NORTHWEST ASSOCIATED CONSULTANTS, INC.

MEMORANDUM

RE: Sunfish Lake – MABM, LLC Site and Building Plan Review, and
Conditional Use Permits; 2400 Delaware Avenue

RE: **Revisions Summary**

A3

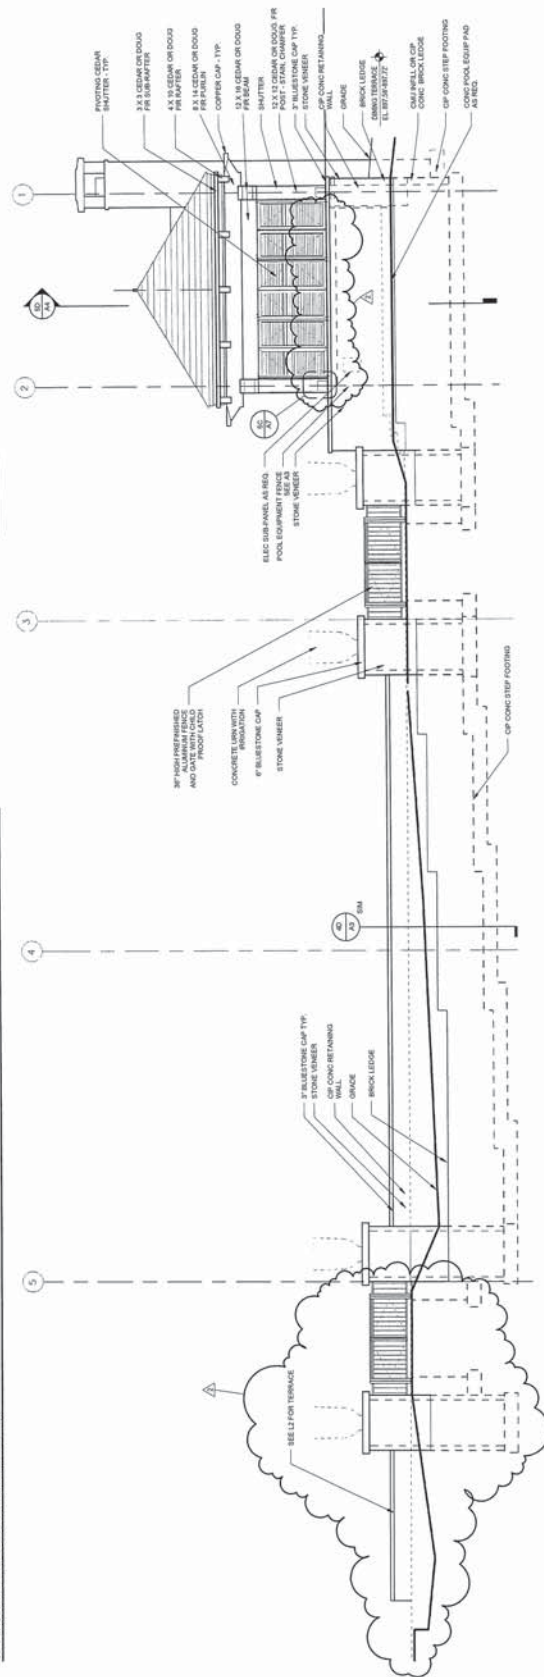
- a. **Response:** ~~See attached plans and elevations for pool utilities screening fence information. Fence height is six feet above grade.~~ Per requirements of Ordinance

section 1218.03, a combination of a 4'-0" solid fence and 6'-0" green belt planting is provided. See L2 plan and Sheet A3.

DRAWING NUMBER:
A6

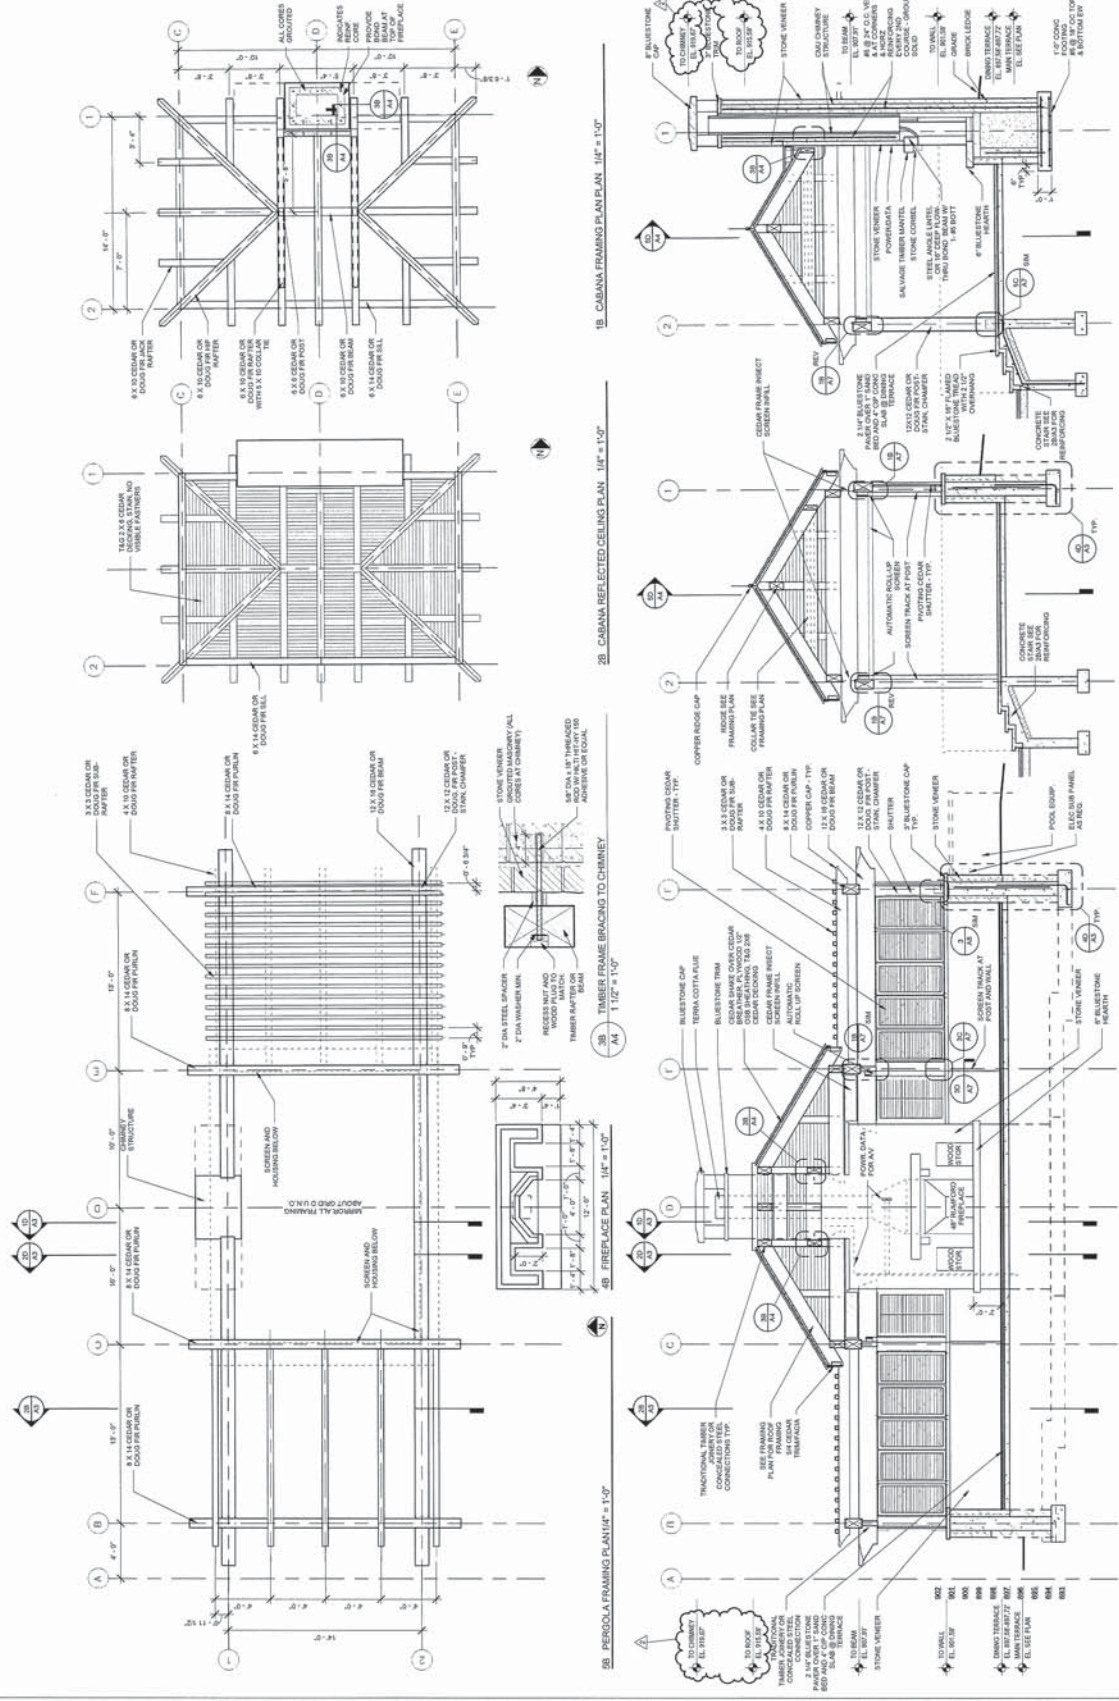
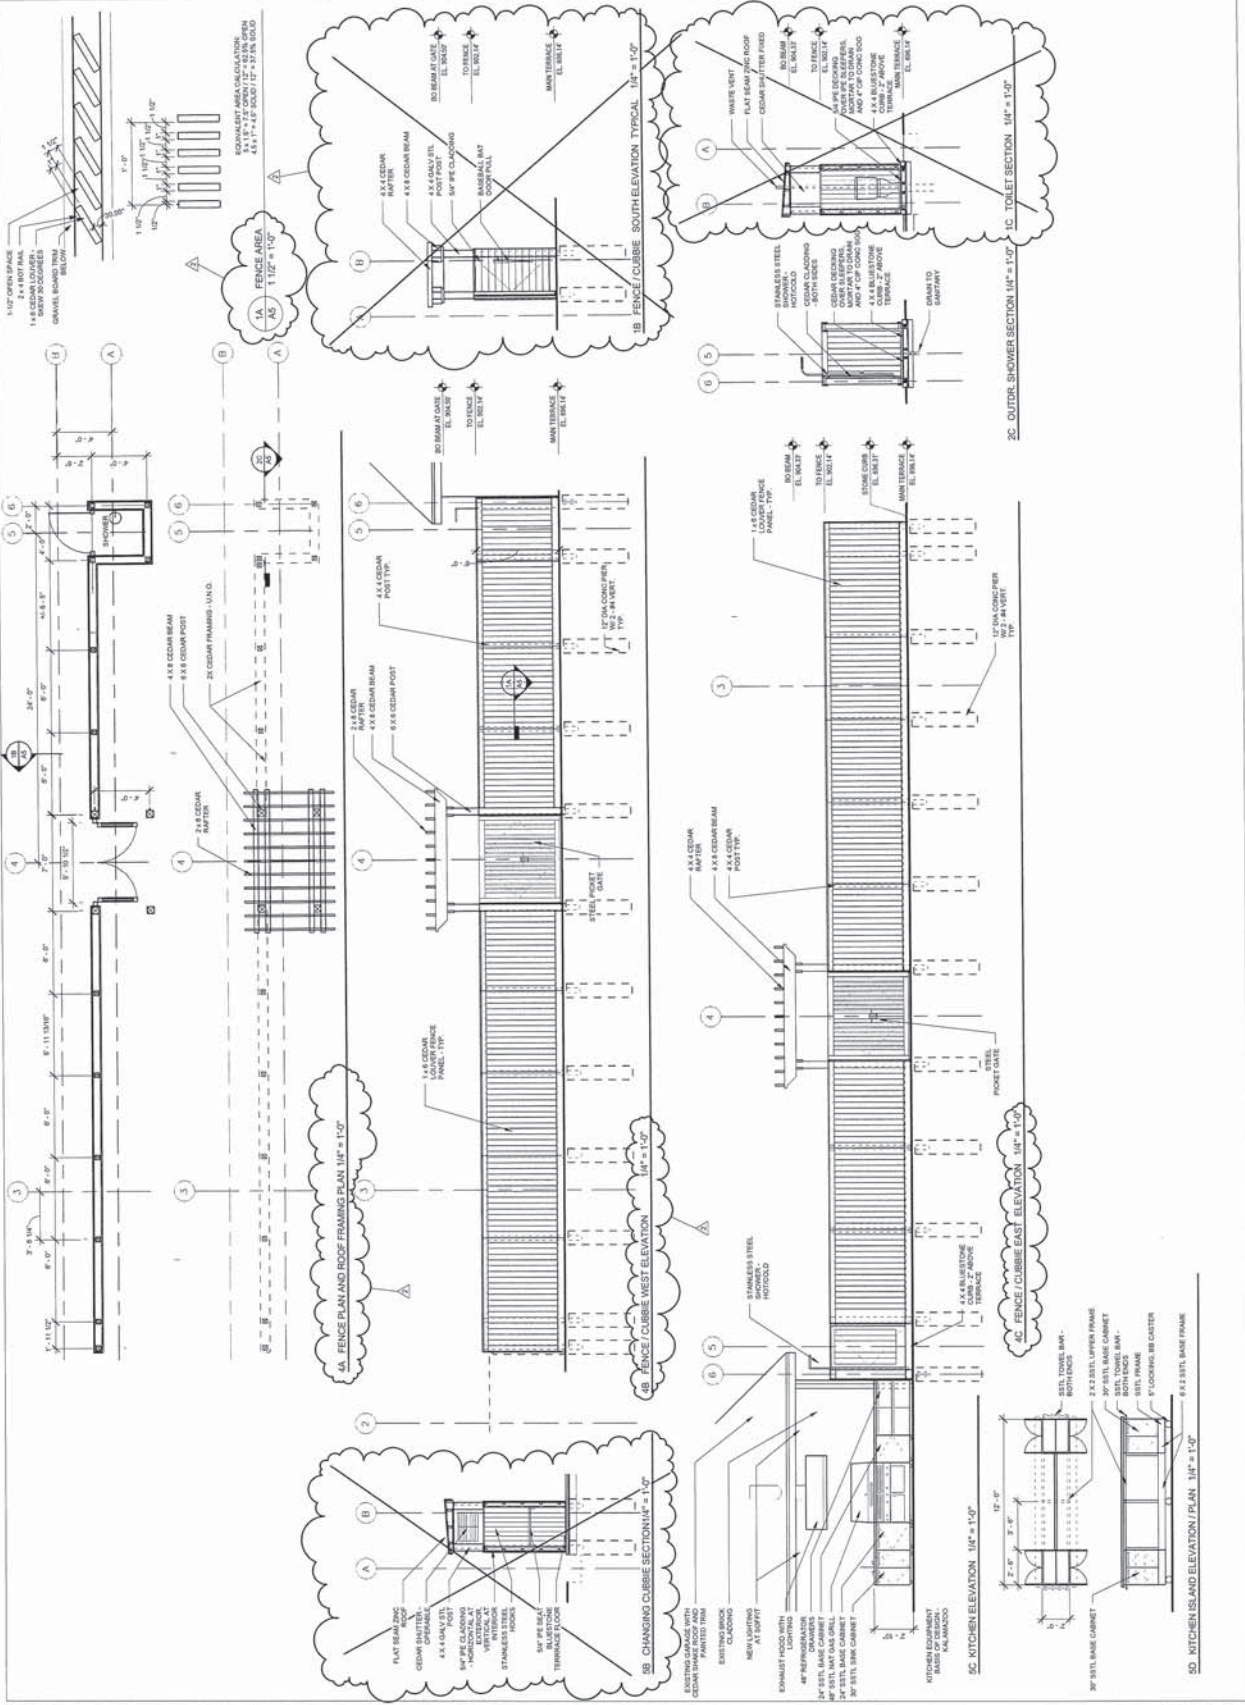
- a. **Response:** See L2 for line type legend. All plumbing will meet all applicable codes.
4. *The sanitary sewer connection to the shower was not shown on the plans.*

- a. **Response:** See L2 for connection to sanitary sewer system and A6 for curb design.
5. *The proposed septic system line style should be solid to indicate this system will be constructed with the project and is not existing. If the sanitary sewer line connection to the existing system will be removed as part of the new construction is (sic) should be noted on the plans. Any septic system line that will be abandoned should [be] indicated on the plans. The sanitary sewer system and septic system elevations should be shown on the plans. The proposed septic system should be inspected and approved by the City septic system inspector.*

L1 OF 3

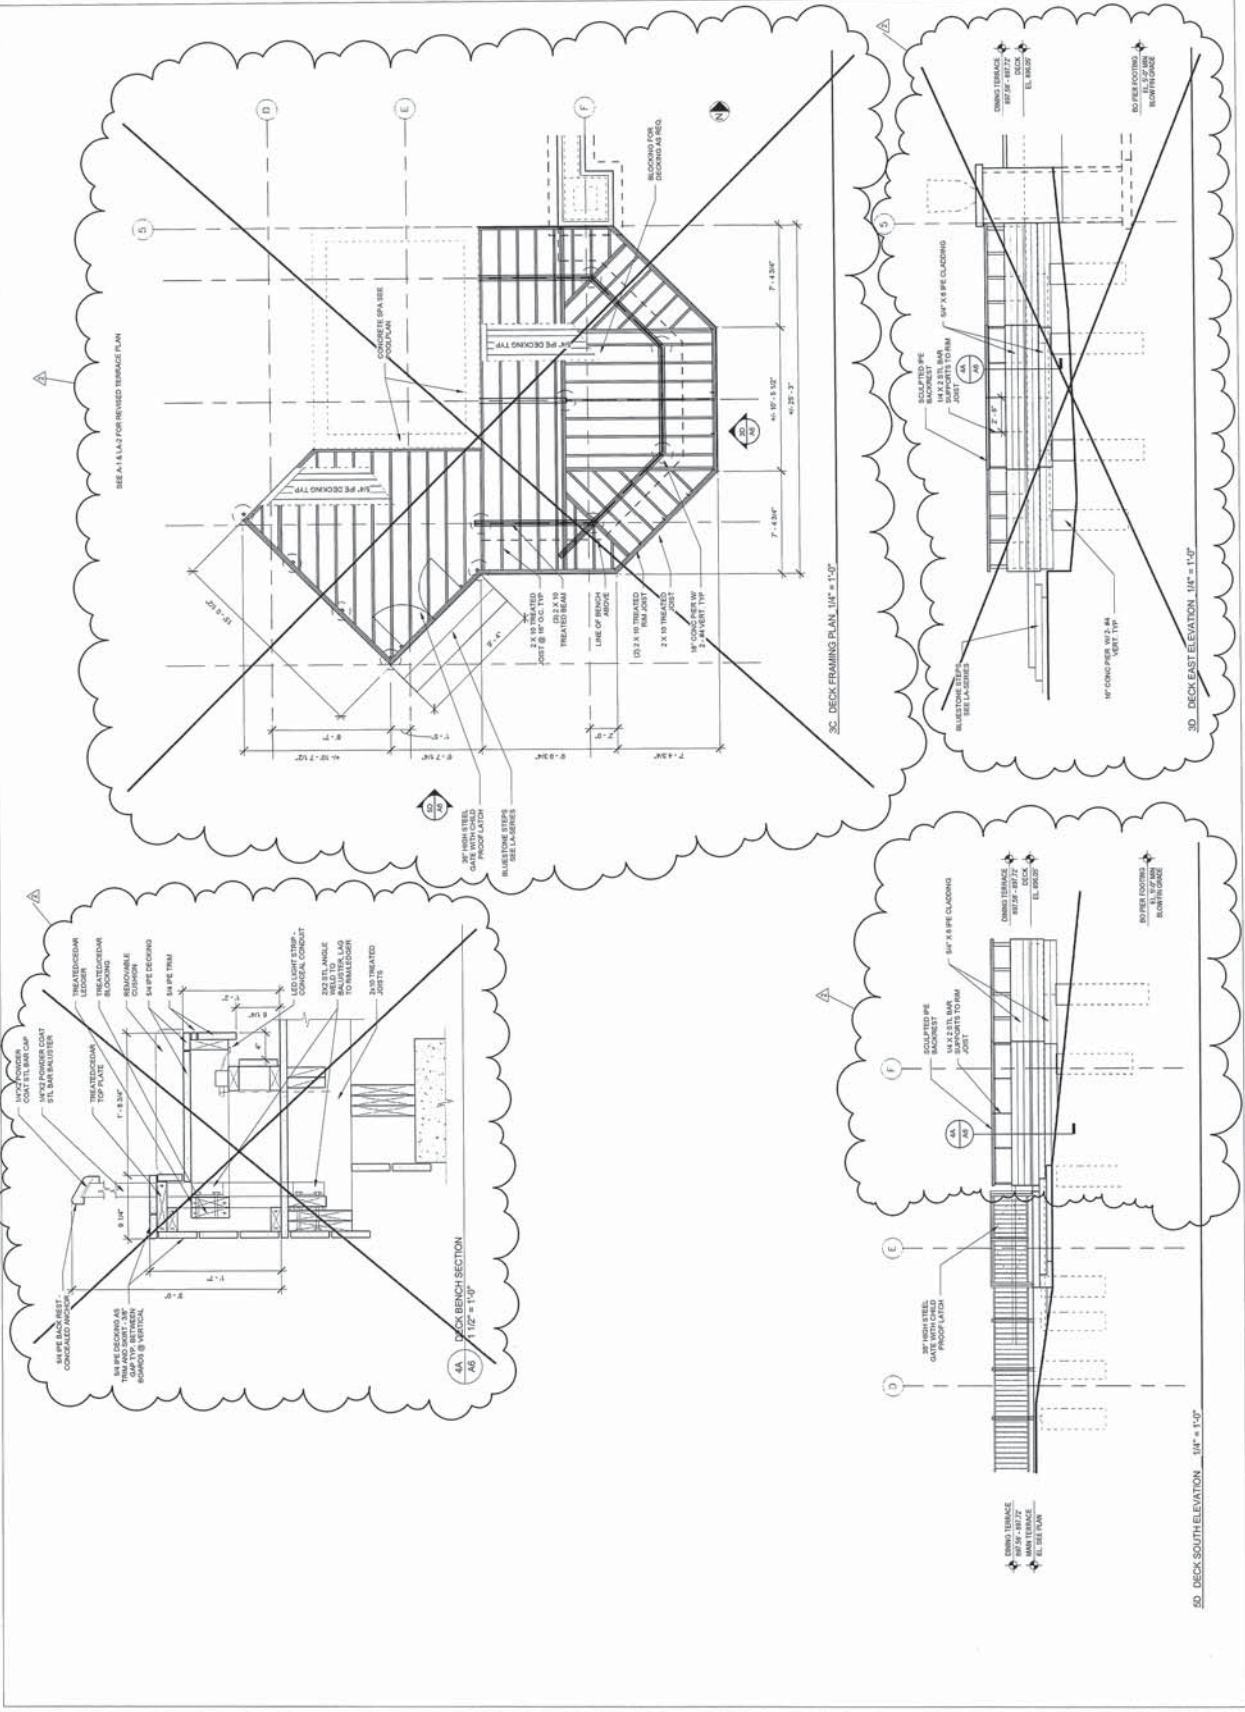
- a. **Response:** See A1, L2.
7. *The rain garden located above the drain field shown should be moved to avoid saturating the drain field area. Also, size of the rain garden should be adequate to contain the winter draw down of the pool to provide a filtration opportunity.*

3. The storm water pipe crossing of the driveway is not shown on either sheet L2 or L3. The plan sheet L2 limits shown on sheet L1 do not illustrate the pipe crossing the driveway. It is requested that one of the sheets illustrate the driveway crossing.

- a. **Response:** Rain Garden for pool drawdown has been relocated to west of parking area, west of pool. See L1.
- 8. *The plans show an area behind the pool where trees and shrubs are being removed. This area needs to be stabilized with new vegetation and/or turf.*
 - a. **Response:** See L2 for landscape planting plan.

L2 OF 3

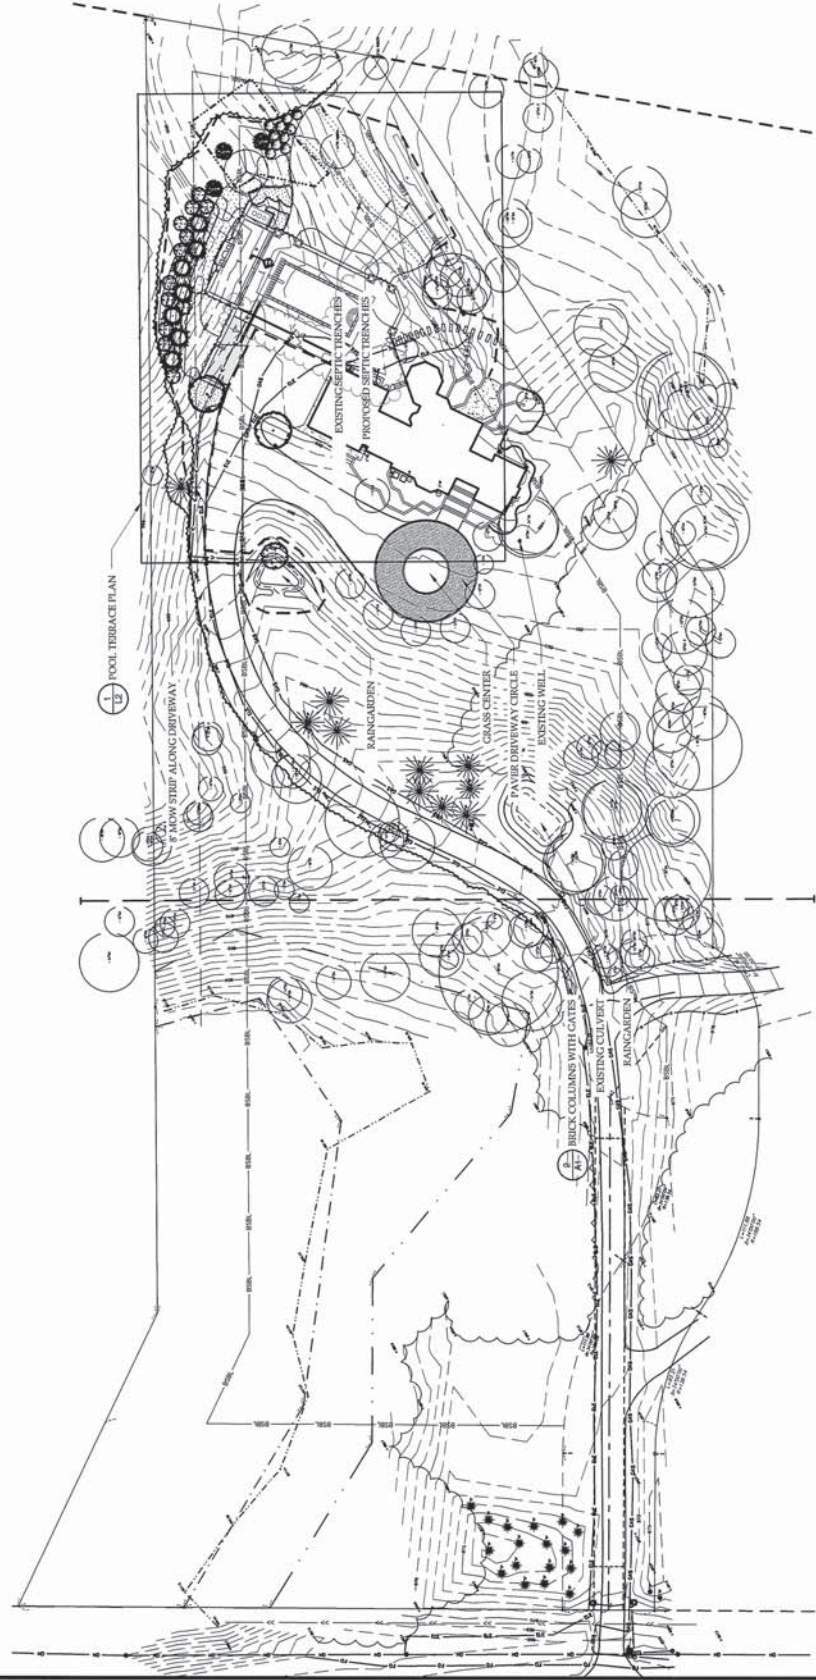
1. *The proposed trench drain outlet pipe invert elevations to the east Rain Garden should be shown on the plans. The elevations of the system should be verified for constructability.*

3. *The sanitary sewer system serving the outdoor toilet should meet the City building codes. The sanitary sewer line style on the plan should be solid to indicate that this system is not existing.*

6. *The deck elevations should be shown on the plans. The proposed footings for the deck should be shown on the plans and the footings should be clear of the proposed sanitary sewer to the septic system.*

- g. It is recommended that the proposed Bur Oak be moved away from the storm drainage pipe serving the pool. Sheet L2The tree roots could affect the pipe and may impact maintenance or replacement.

5. It is recommended that the proposed Bur Oak be moved away from the storm drainage pipe serving the pool. (Sheet L2) The tree roots could affect the pipe and may impact maintenance or replacement.

- a. **Response:** See L2 and L3.
2. *The waterline services to the outdoor shower and facilities should be shown on the plans.*
 - a. **Response:** See A1

- a. **Response:** See L2. See attached revised septic system expansion design dated 7/31/12 for system location, elevations and alternate drain field area. Inspection of system tanks will be completed following excavation to expose tanks nearest residence. Modifications to system tanks will be made if required to meet all applicable codes.

Driveway Plan

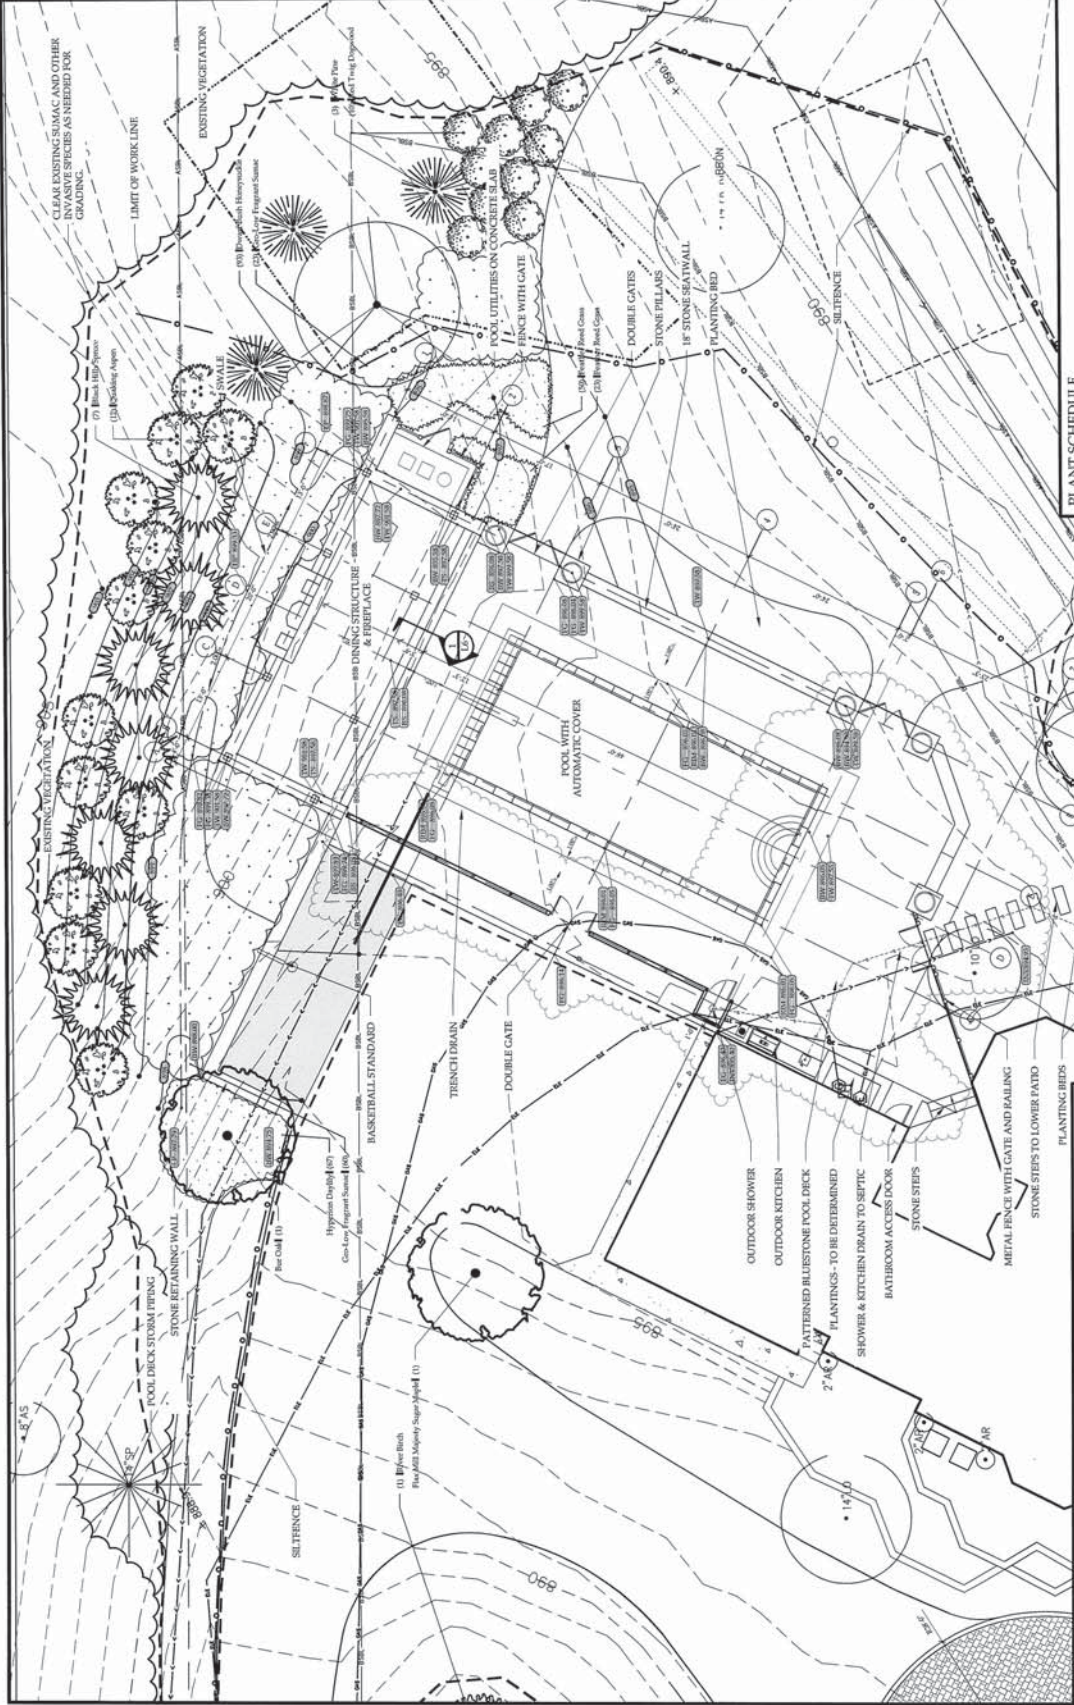
- e. The storm water pipe crossing of the driveway is not shown on either sheet L2 or L3 The plan sheet L2 limits shown on sheet L1 do not illustrate the pipe crossing the driveway. It is requested that one of the sheets illustrate the driveway crossing.
